(3512) Southern Schools Cluster (SSC)

Re: GANSW Comment on Booster for NLPS SSD

the booster near the main entrance, should be concealed to improve the amenity of this public zone.	S
---	---

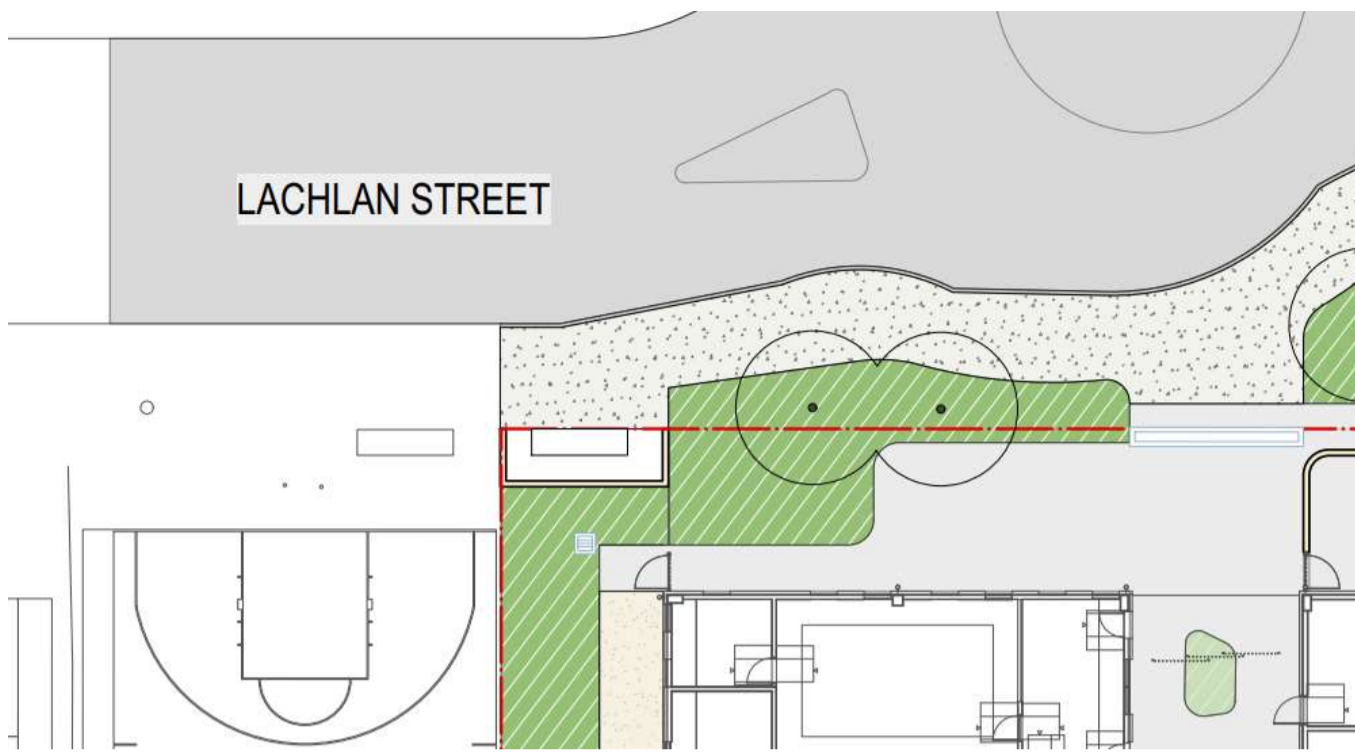
Are you able to provide a very brief statement today explaining to GANSW that, from a compliance perspective, we cannot screen the front of the booster?

My understand is that the only method of concealing a fire brigade booster assembly permitted by AS 2419.1 - 2005 is via a cabinet designed in accordance with this standard (50mm high signage, clear space in front of the assembly maintained, cabinet generally painted red, etc.).

There would be no opportunity to provide any further shielding or screening as this would obstruct the clear space between the booster and the hardstand (the road). Further noting that providing any form of landscaping in front of the booster would not meet FRNSW's operational requirements (based on past experience of having to concrete areas in front of booster assemblies where FRNSW has picked this up as an issue on site).
